**Objection letter**  
Against  
**Planning application P/20/054/FUL**  
At  
**Garage, Buzza Road, Hugh Town St Mary's**  
For  
**Demolition of garage and construction of Local Need Dwelling.**

**Mr and Mrs May**  
Of  
**The Lookout, Porthcressa Rd, Isles of Scilly TR21 0JQ**

**23/10/2020**

Figure 1 Sun path in relation to The Lookout and the site

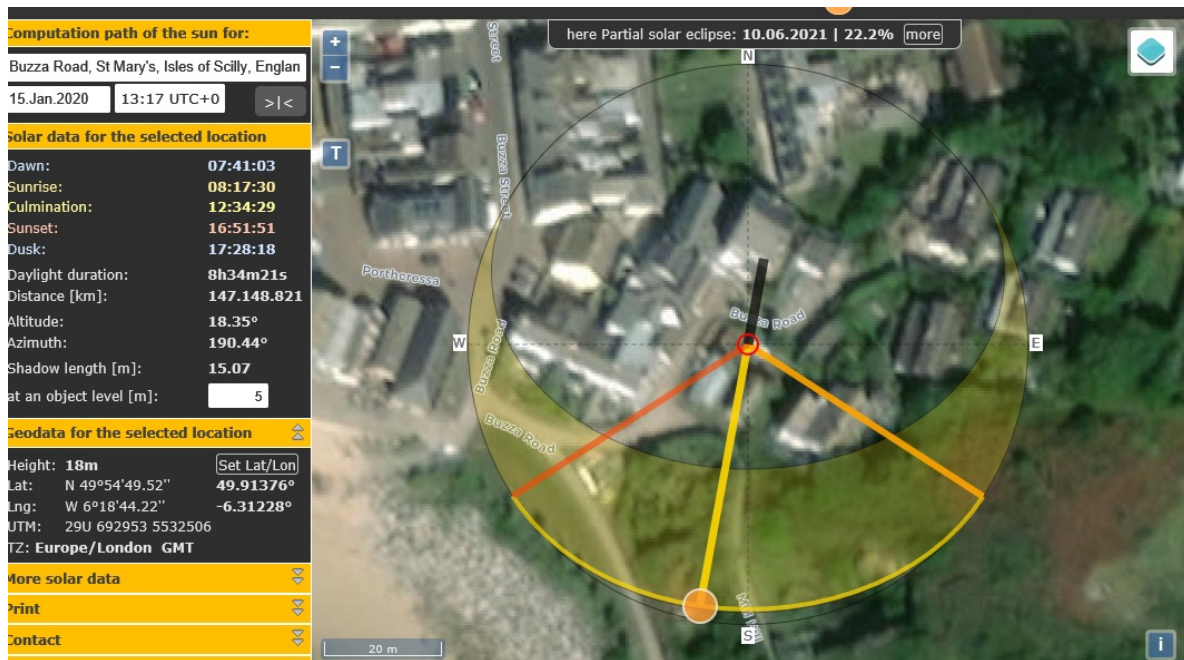
Figure 1 is a simple map taken from [suncalc.org](http://suncalc.org). This indicates that there would be possible overshadowing as a result of the siting of a two storey dwelling to the south east of The Lookout. The Lookout's windows are south facing and light to these, particularly those to the eastern side of the front elevation, would be affected by the proposed dwelling. The Lookout has enjoyed a relatively open and uninterrupted outlook and this new building would have a high flank wall close to the Lookout. There is very little separation between The Lookout and the application site owing to the narrow lanes between the properties and the general proximity of properties in the area.

Figure 1 indicates the position of the sun at 1pm when it is considered there would still be some overshadowing of the front terrace and windows in The Lookout. It does not appear that the officer has made reference to the Lookout's patio which will sit closer to the development than its front elevation and as such we consider that this impact has not been fully considered by the officer.

Figure 3 comparison the illustrated north and the actual north

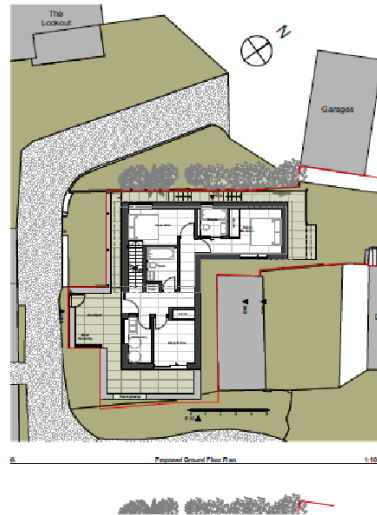
We also consider that the north arrow on the plans gives the impression that the proposed dwelling will be more to the east of the Lookout than it will be in actuality. Figure 3 shows a comparison between the placement of the north arrow on the applicant's plans and how this appears when the drawing is rotated to align with the northern arrow. As such we consider that the overshadowing of

the patio and front windows will endure for longer than stated by the officer and we believe that the impression given by the placement of the north arrow on the drawing is inaccurate and misleading.
